工程指示 / 要求簡箋(E.I.)

工程編號　：**J - 837**　　工程名稱　：觀塘裕民坊

工程項目　：幕牆 隔音要求資料

Re: Design, Supply and Installation of Curtain Wall, Aluminium Window & Door to Tower for N.K.I.L. 6514, Kwun Tong Town Centre (Development Areas 2 & 3), Kwun Tong, Kowloon.
Submission of Sample and Catalog for Acoustic Materials for Curtain Wall

DATE: 11/2017		SCALE: 1:20	
DRAFTED: (HPC)	CHECKED: (CLC)	DESIGNED: (PYC)	REVIEWED: (DT)
JOB NO. 31690	DRAWING NO. T/A132/105	REV. NO. (12)

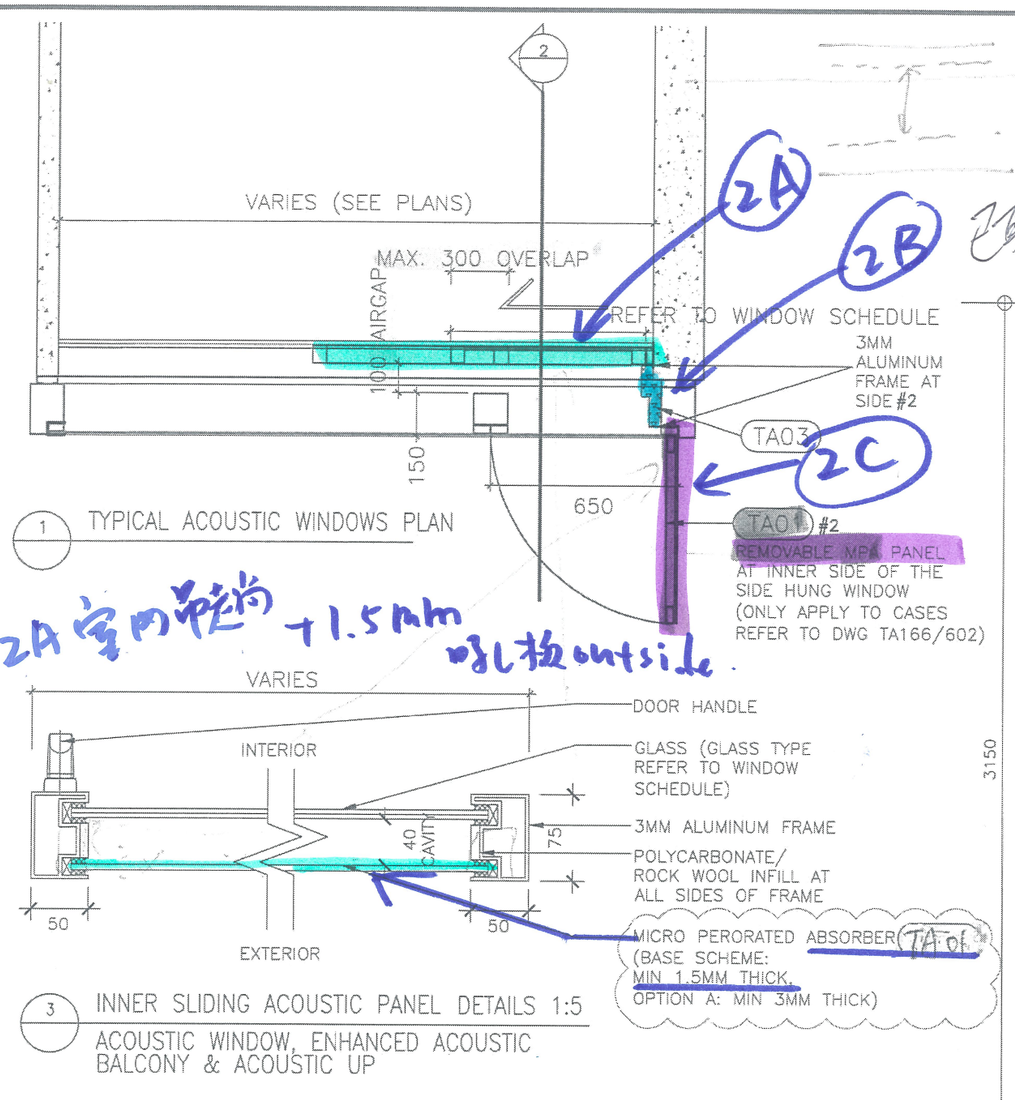
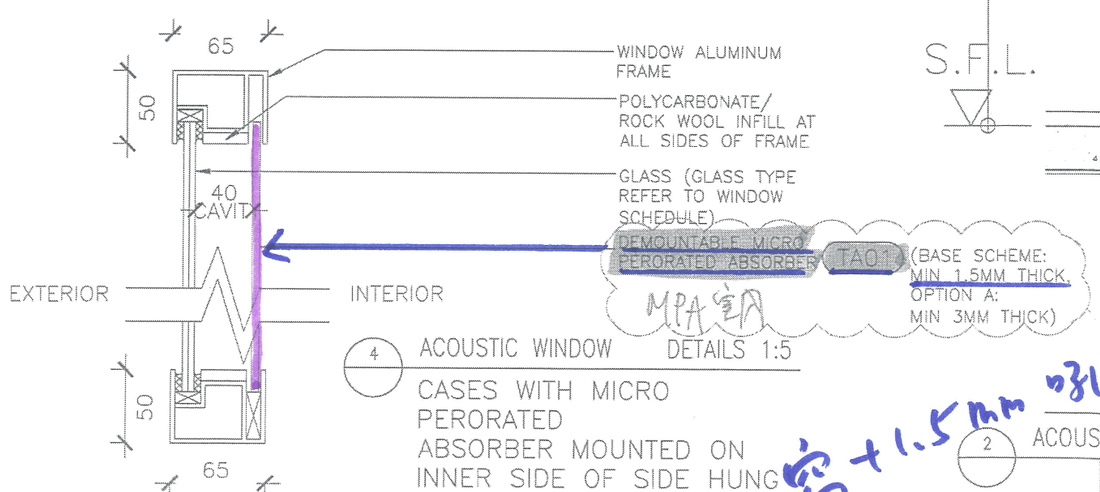
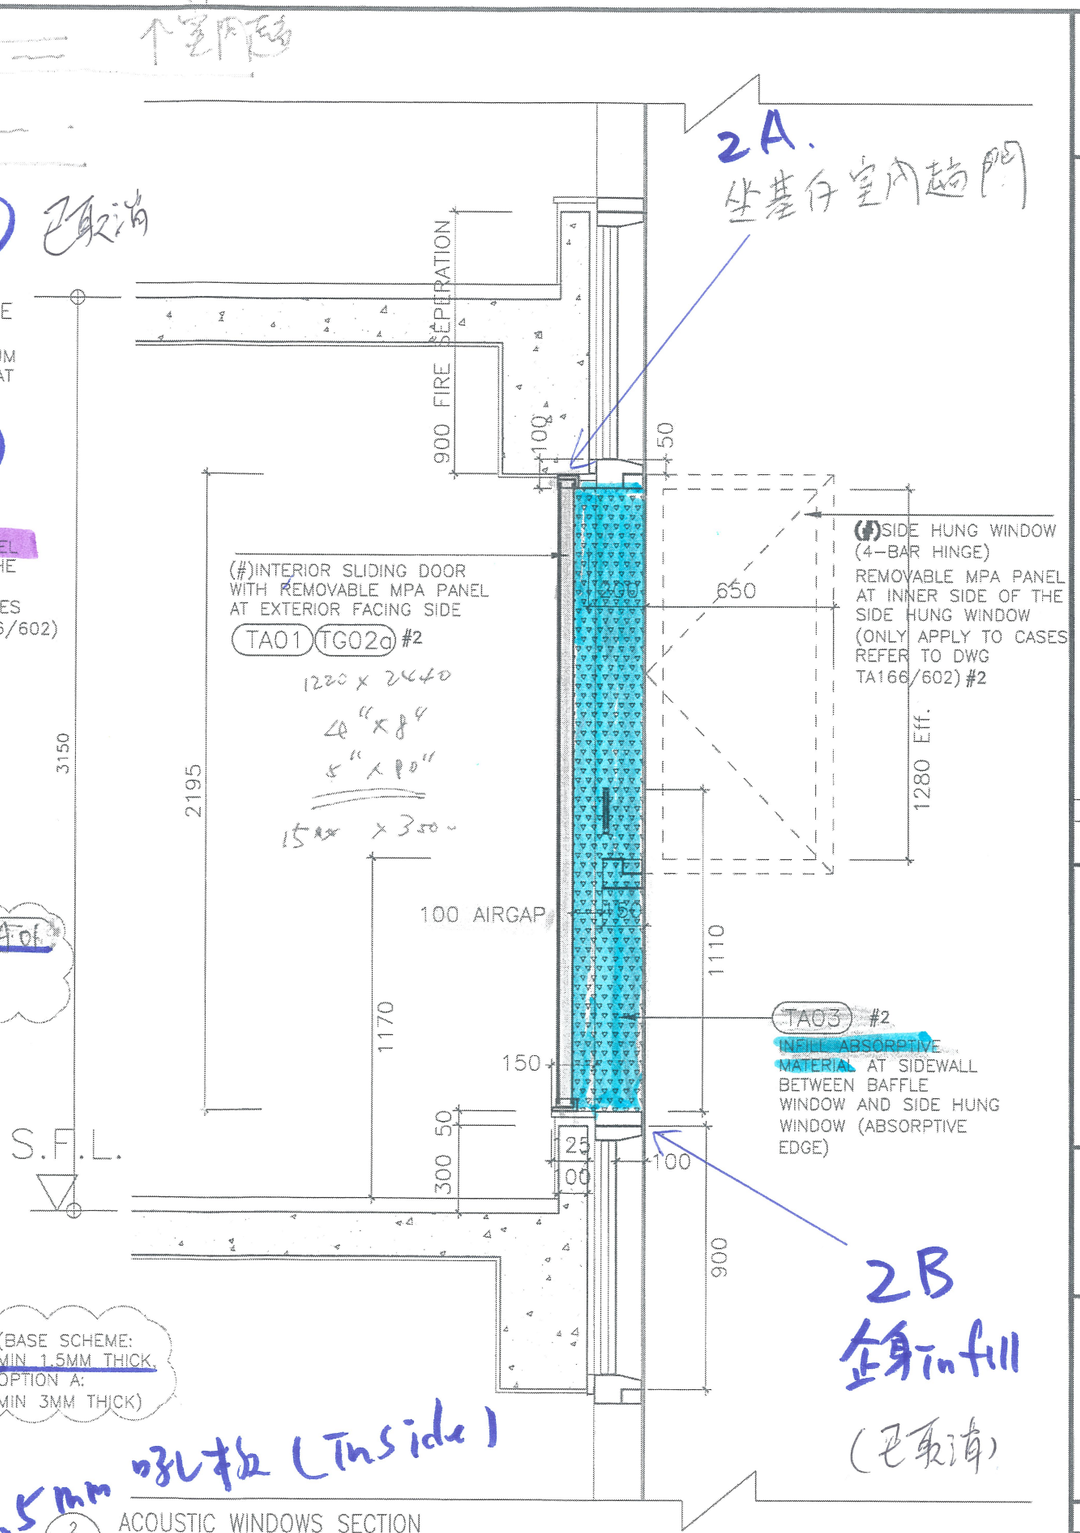
(已取消) (2B) ~~全身infill~~ +

(2A) 室內窗

(2C) 1.5mm 吸收板 在生窗

2C 窗 +1.5mm 吸拉 (Inside)

DATE: 11/2017		SCALE: 1:20	
DRAFTED: (HPC)	CHECKED: (CLC)	DESIGNED: (PYC)	REVIEWED: (OT)
JOB NO. 31690	DRAWING NO. T/A132/105c	REV. NO. (07)

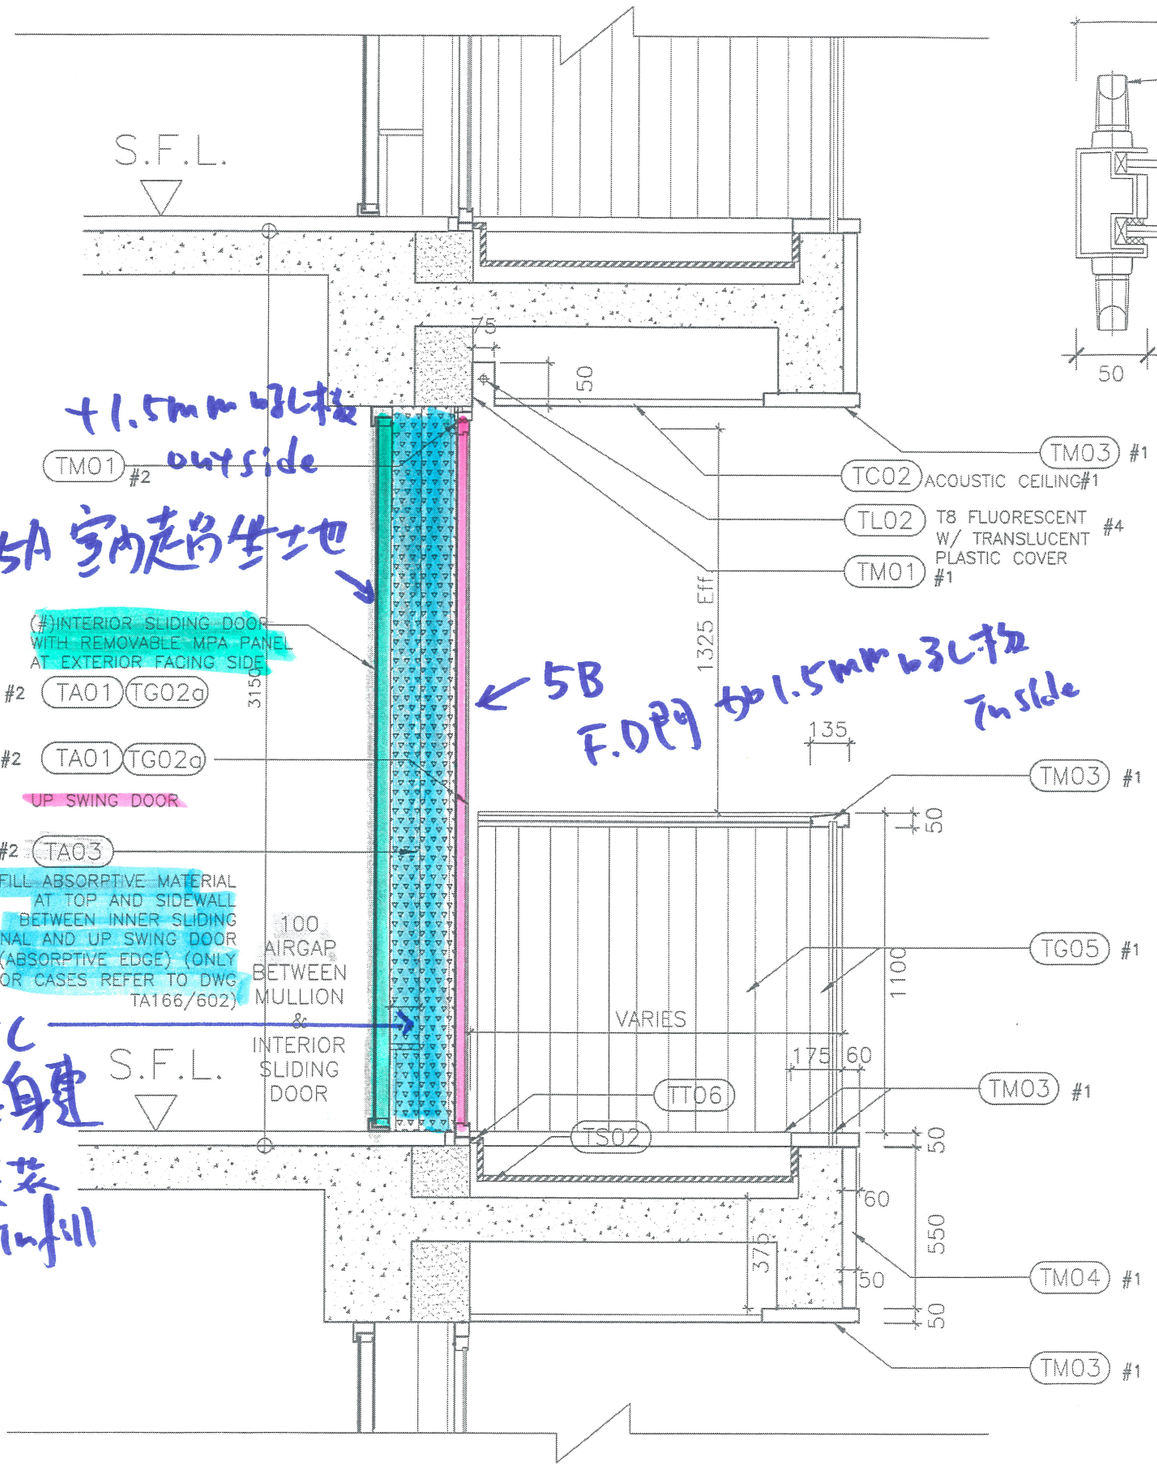
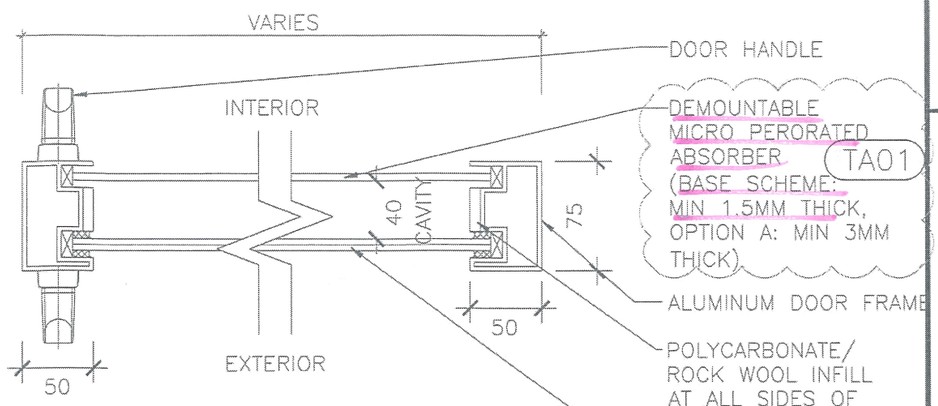
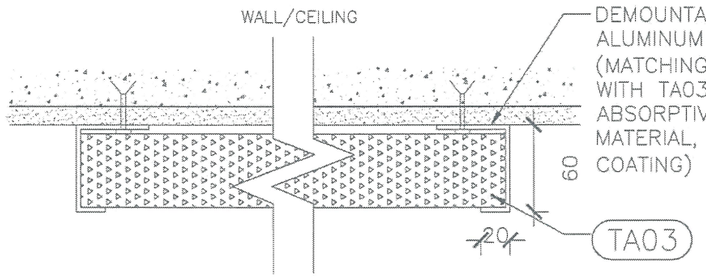
(4B) F.D門 加 1.5mm 吸收板

(4C) ~~全身連天花 Infill~~ ×

已取消

(5B) F.D門 加 1.5mm 吸收板

(5C) 全身連天花 Infill
